WAT-FORM-11: Groundwater Abstraction Application Screening Assessment

Site Name & Work Request No.	Portintruan, Islay	CAR reference	CAR/R/5004458
NGR(s)	BH5 138202 645942 BH7 138233 645900	Location Code(s)	n/a
RS Contact	[REDACTED]	Date Assessed	20/03/2024
Abstraction Type (borehole, spring)	2 boreholes	Max Abstraction Rate	200 m ³ /d, 73,000 m ³ /yr
Abstraction Aquifer	Bedrock, GWB ID 150683 (Islay), FL	Abstraction Purpose	Industrial, distillery
Abstraction Frequency (permanent or temporary, seasonal or all year)	Permanent all year round	Author(s)	[REDACTED]
		Reviewer(s)	[REDACTED]

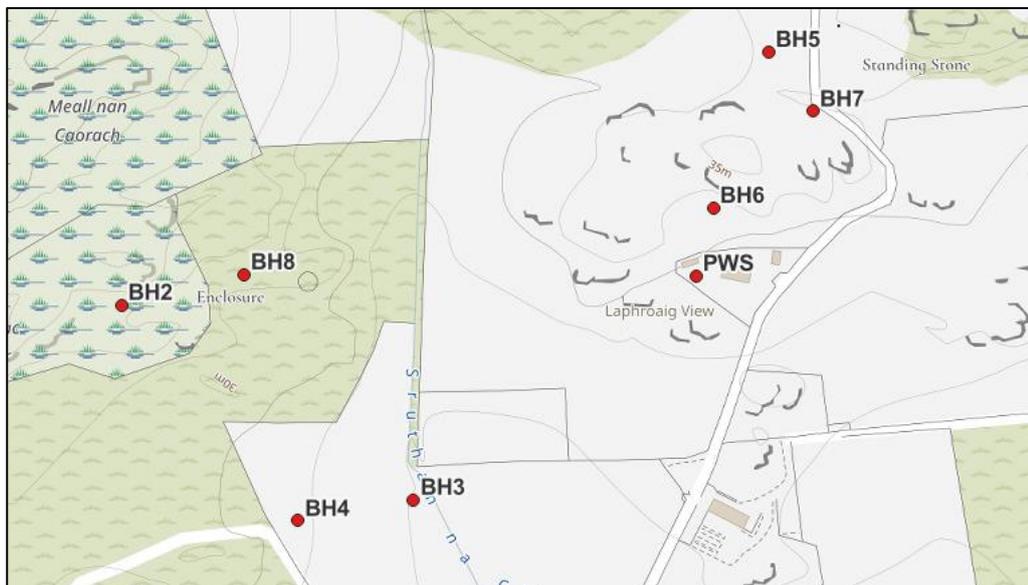
There is one known existing groundwater abstraction, a Private Water Supply (PWS) within 850m (radius for Water Feature Survey) of the site. The PWS is serving Laphroaig View premise and used for human consumption (domestic and commercial bed and breakfast). Several boreholes have been installed by the applicant in the area to obtain the needed abstraction rate. The information on the boreholes and PWS are summarised in the following table (* Laphroaig View daily water use based on 5 people permanent occupancy).

The following figure shows the spatial distribution of the installed boreholes and the location of the PWS:

The applicant has undertaken several pumping tests to quantify the abstraction rate obtainable from BH5 and BH7 and evaluate the impact on the PWS receptor. The main tests of interest are the constant rate pumping tests performed in BH7 and BH5. During these tests groundwater level measurements were taken also at BH6, BH8 and water levels at the Sruthan na Cille water stream.

Both BH5 and BH7 were used in alternance as observation wells during the pumping tests. Groundwater levels in BH5 and BH7 reacted to the pumping on the other borehole. This was expected as the two boreholes are 52m apart and drilling logs show intercepting productive fracture zones at the same depth of 30mbGL. Observation wells located further apart, namely BH6 (100m from BH7 and 115m from BH5) and BH8 (415m from BH7 and 400m from BH5) did not show any appreciable lowering of groundwater levels during the pumping tests. Similarly, the water level measurements taken at the Sruthan na Cille water stream did not show appreciable variations.

The applicant concluded that the cone of depression is of limited extent and may not have propagated to BH6 during the test period. WRU agree with this conceptualisation pointing out that the limited testing period (24h) may have been too short to induce any effect on BH6 from the pumping action at BH7. This however may differ if BH7 is pumped continuously every day to the proposed abstraction rate.

The applicant progress to the interpretation of the drawdown and recovery curves (resulting in a transmissivity of 51m²/d) and calculates the potential radius of influence using the Sichardt equation which, for an aquifer thickness of 59m, results in 56m radius from BH7. The applicant warns that (quoting) '*this ROI (radius of influence) calculation is an initial estimate only and should be treated with caution*'. The use of the Sichardt equation in this case is not supported by WRU as based on empirical not documented/published methodology, used mainly as a rule-of-thumb to assess the radius of influence for excavation dewatering. As an alternative WRU used the distance-drawdown graphic solution based on the drawdowns in BH7 and BH5 during the BH7 constant rate pumping test, obtaining a radius of influence of approx. 125m from BH7.

Either of the above methodology however are heavily constraint by the assumption that the aquifer is homogeneous, isotropic, uniform in thickness and that the pumping test has reached a steady state, all assumption which are not applicable to the fractured aquifer and the length of testing at the Portinruan site, resulting in a great uncertainty around the potential reach of the radius of influence during BH7 operational conditions (i.e. 200m³/d every day). As such an impact of the BH7 abstraction on BH6 and the PWS cannot be excluded. The significance of such impact could be assessed by the continuous monitoring of groundwater levels in BH6 during BH7 operational use.

The applicant suggests that a longer testing period is needed to assess impacts on the PWS and saline intrusion risk. On these basis WRU recommends conditioning the BH7 and BH5 abstraction authorisation to the continuous monitoring of groundwater levels in BH6 for 1 year during BH7 operational conditions. A threshold of 1m groundwater level drawdown in BH6, not attributed to natural events (e.g. period of drought), should trig the reduction or temporary cessation of the abstraction in BH7 till the BH6 levels are recovered to natural conditions. After 1 year and upon assessment of the monitoring results the application of the condition can be revised or withdrawn. Details of the recommended conditions are forwarded to SEPA Water Permitting in the WAT-FORM-14.
